I have three specific recommendations, which I have proposed to CC at Play, regarding how the fields complex could be a more flexible design, at lower cost, than the current design which was first promoted in October 2013. Through June 2013 (no public presentations again until October) the proposed layout had tennis and basketball courts 'on the hill' but in October the tennis courts were repositioned near the stadium. Since the fall, the layout has only been altered in minor ways to meet regulatory requirements. Some of those seemingly minor changes have had significant functional and cost impacts. Here are the suggestions I have been proposing since the October presentation of the current arrangement:

Detailed Analysis

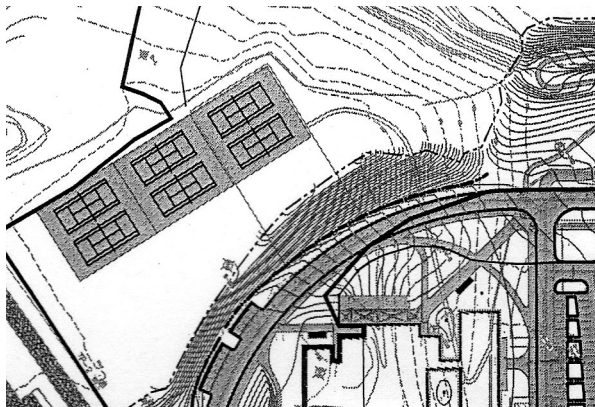
The CC at Play plan places a full size multipurpose field at this location. I believe a field surface is a good outcome for the ash dump remediation area under the current student parking lot. Neither the School Committee nor CC at Play has considered this area as a possible location. The additional cost to the remediation plan of covering the parking area with loam and grass would be minimal, whereas the costs associated with regrading for a full size field 'on the hill' are far higher than a tennis alternative at that location. There would be a delay getting a field at the current student parking location, as it is also in the building construction envelope.

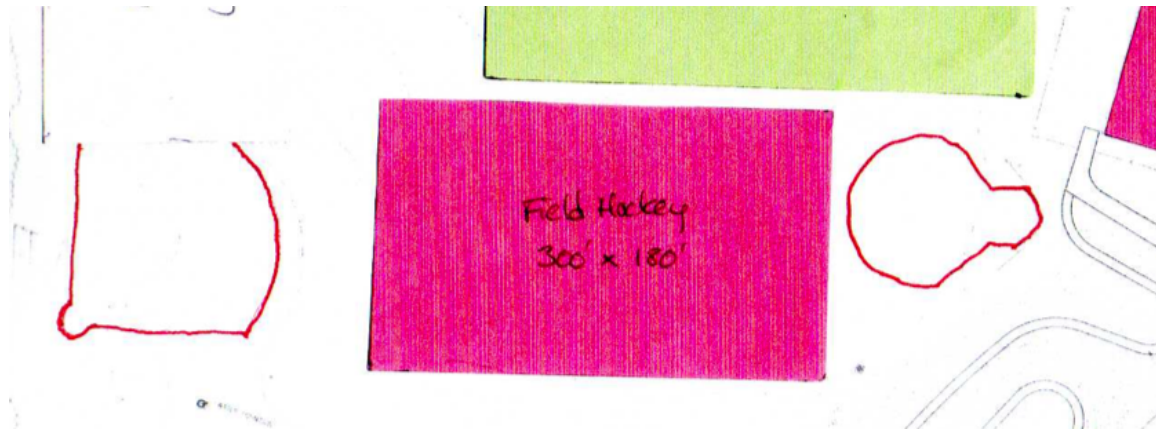
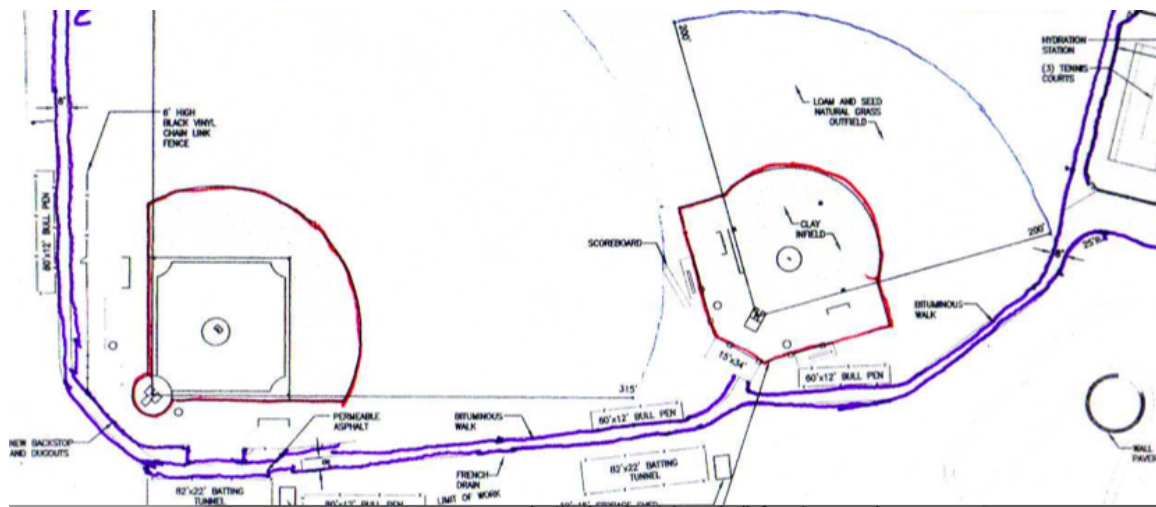
Note that due to the 6 court tennis proposal, even if the alignment of the softball diamond remained the same as it is today, it would need to push out somewhat due to the encroachment from the tennis courts. However, I believe that 100yds between the infield skins would still be possible with a careful design, along with the requirements of outfield depth for both diamonds. This may entail added expense to

create a retaining wall, as the area contains steep grades. If the tennis courts were not built at this location, the field could stay in approximately its current location, without added regrading.

The single goal of rotating this diamond is the creation of an ideal sun orientation for the field. I believe this consideration, regardless of how it is characterized ('gender equity' with boys baseball, safety, because sun is minimized in all players' eyes) is too great a compromise to the overall utility of the layout. Loss of general purpose space for single season, single sport use must be weighed very carefully and there has been no public discussion of this compromise. The Town made a similar decision when building the 60ft diamond at Ripley – the loss of a full size multipurpose field for the diamond (along with some arable farmland). The result here is a permanent loss of a fall sports field space for high school use and summer camp rental field for soccer or lacrosse camps.

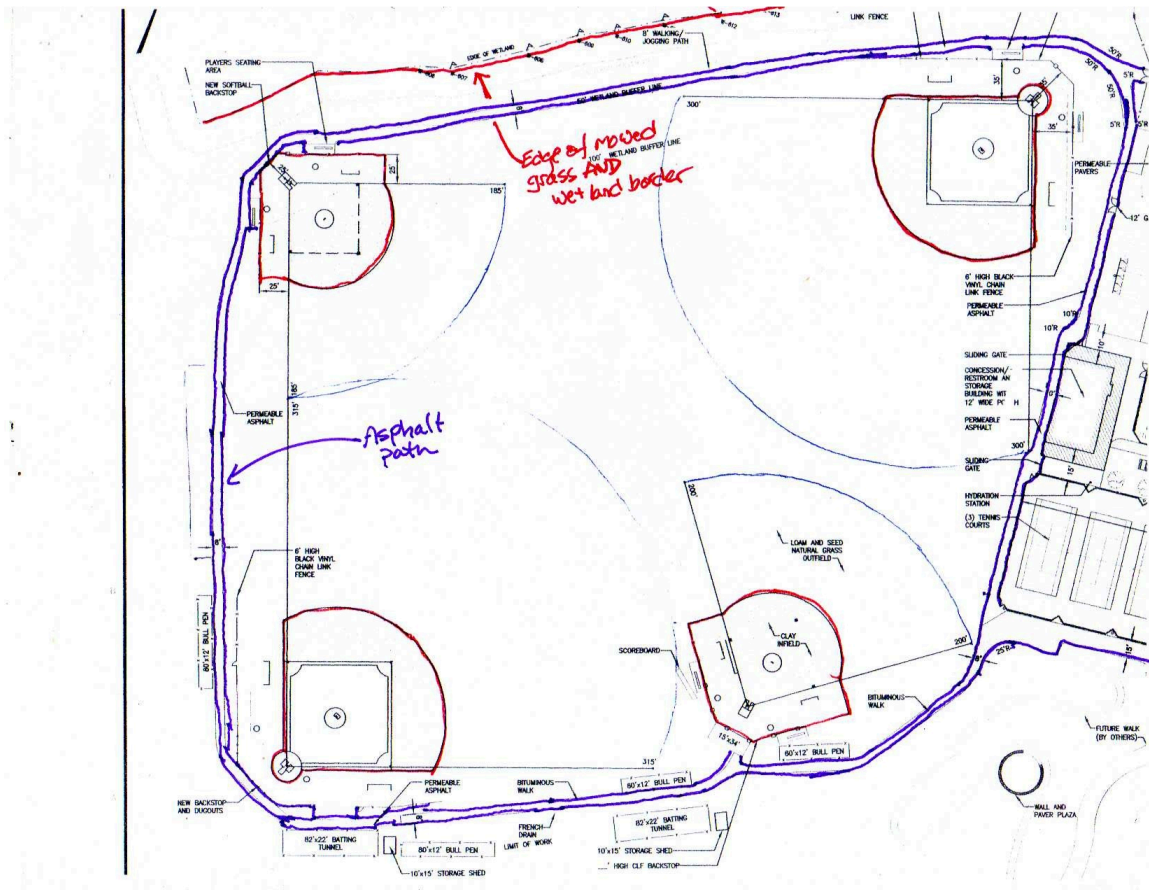
Here is a picture of the lower complex with the proposed drive highlighted in purple. The red line on the northern side of the fields is a wetland boundary.

I believe the ring should be truncated at the two JV (northern) diamonds and not continue along the northern edge. By continuing around, the plan automatically engages the Wetlands Protection Act (WPA), and this has resulted in multiple expensive (cost and usability) changes in the original concept that I feel are unwarranted. These are totally avoidable with a design that leaves the grandfathered uses alone along that sensitive area. Bringing that access down the sides of the field to within 100 ft of the wetlands (WPA jurisdictional boundary) is a very good ADA solution for access to the fields. A full loop is not part of the high school athletic program, yet CC at Play persists in including it, to the detriment of the design.

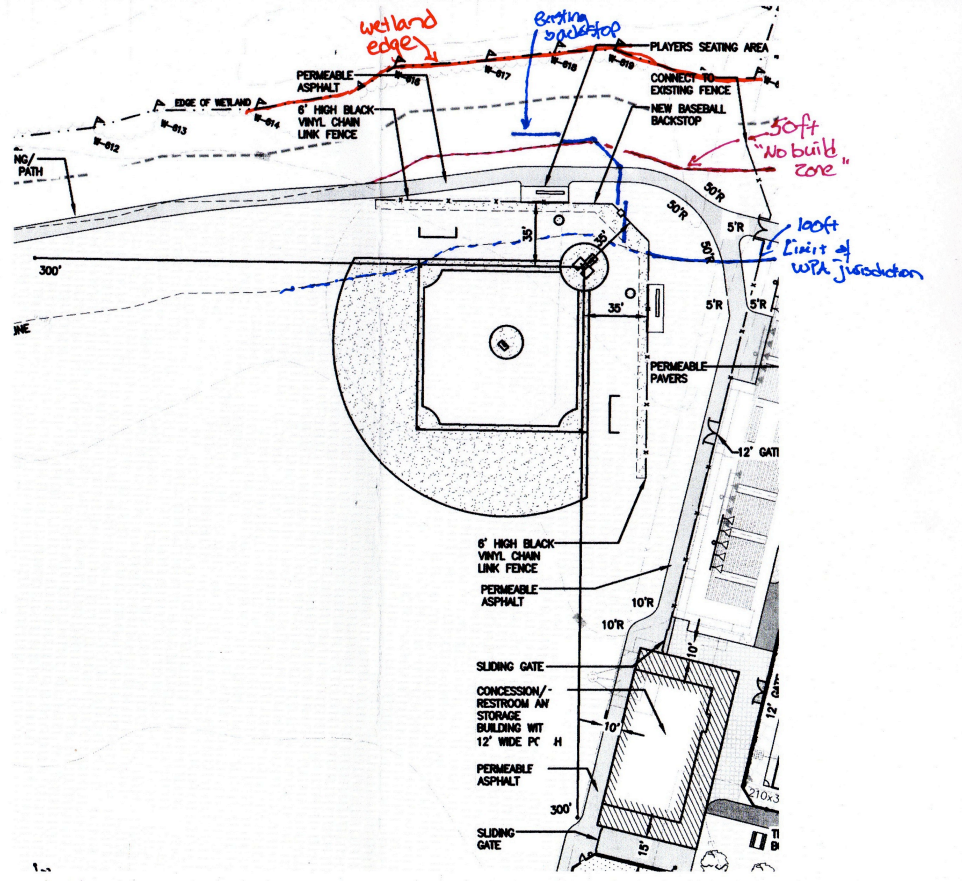
The image below shows in blue where the existing backstop and player screening fences are located for the overgrown/abandoned JV baseball diamond. They are very close to a critical line, 50ft from the wetland edge. Concord has a policy that no structures can be placed within 50ft of a wetland. These are grandfathered. If a backstop of similar scope, not the more extensive fencing and road proposed, were brought to the NRC as a 'replacement in kind', they may allow strict replacement at the current location. If the same scale fencing were moved west 10'-15' and _rotated_ slightly, the bench screening fence now closer than 50ft would rotate out of the 50ft protection zone and the NRC may view that as a nice accommodation of the 50ft rule. I cannot speak for the Commission, and have been very clear that I am recused in this matter. The diamond cannot shift too far west, or the 120 yd football practice field will end up intersecting with an infield, which should be avoided if possible. Due to the extensive new development proposed in the wetland protection buffer, the backstop had to be moved much farther south, as shown, to keep both the fencing and the drive/path outside the 50ft zone. This design leaves the orientation of the diamond the same. This would normally not be an issue, but one reason this diamond is abandoned today is that too many foul balls end up in the wetland and rotating the diamond was a priority of the AD. This could not be achieved due to the need to migrate south so far.

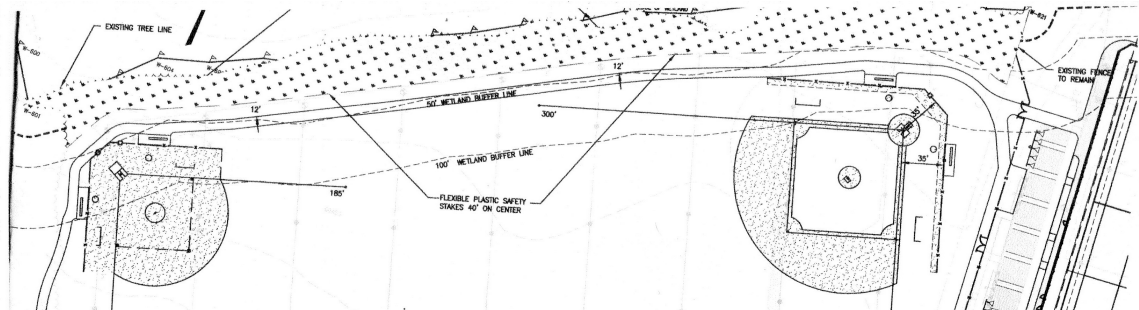
Here is a picture of the final border treatment - 25'-30' of tall grasses, mowed only once a year (dotted area), 12' of mowed strip, 8' asphalt drive, playing field area. This is 50'-60' of usable playing field space that is completely grandfathered for its mowed athletic use, but it is being given away for a vehicle drive that is not required for ADA, and as a walking circuit not a component of the High School athletic program.

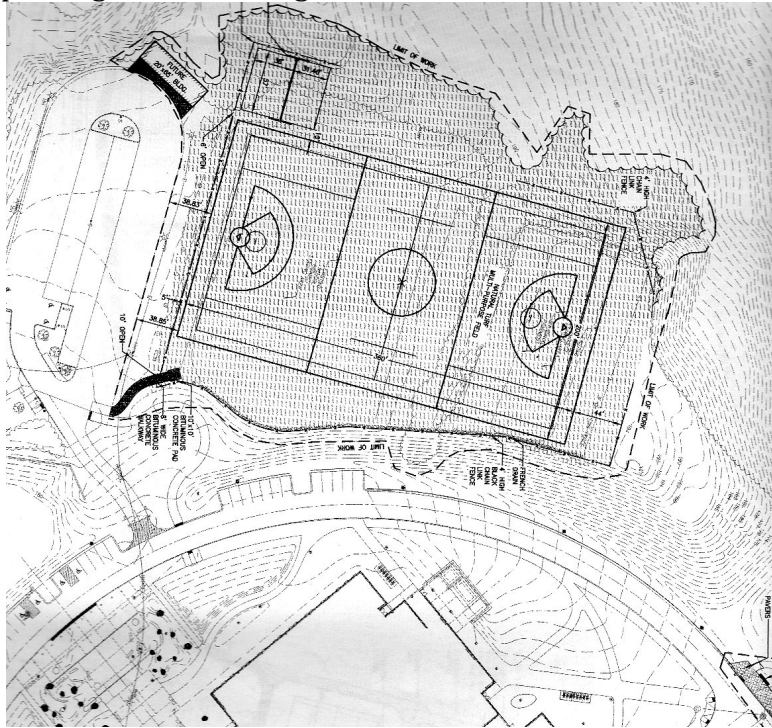
Access Principle – Access generally to the field itself. The operative statement here is "An accessible route is required to connect to the boundary of the area of sport activity. The term "area of sport activity" distinguishes that portion of a room or space where the play or practice of a sport occurs from adjacent areas." 'Connect to the boundary' has been interpreted, in the case of the upper multi-purpose field as a minimal capacity to reach the field, not as a universal ability to

reach the field from all places along its boundary. Note the dark path from the parking lot in the image below:

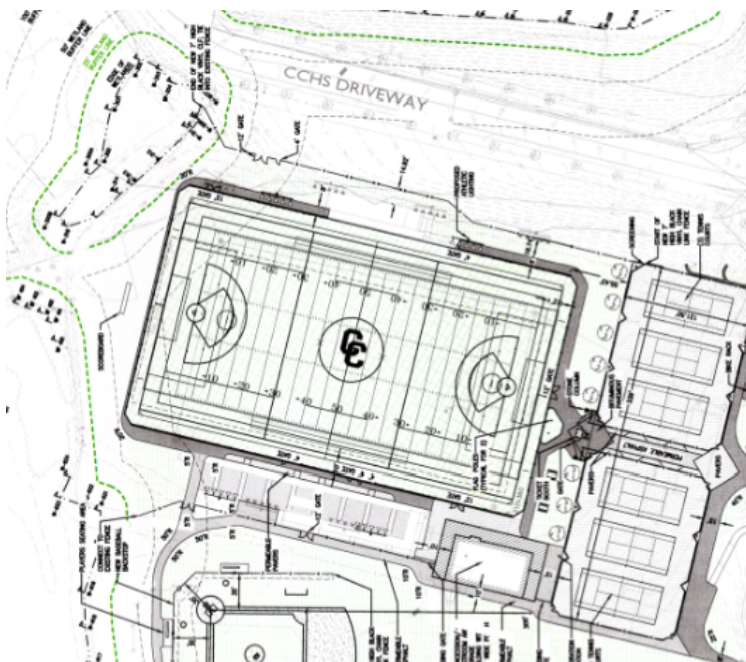
In addition, during permitting, the football stadium field originally had an 8ft wide asphalt path surrounding it, but this was removed due to interaction with WPA regulations, so that field also does not have a full boundary access path. Note the lack of a path on the left side below. Unfortunately, also lost in this final revision were handicapped parking spaces along the CCHS driveway and an accessible path down to the field from them. The parking spaces could have been saved, I believe, by moving them farther up the driveway. That is unfortunate, and avoidable.
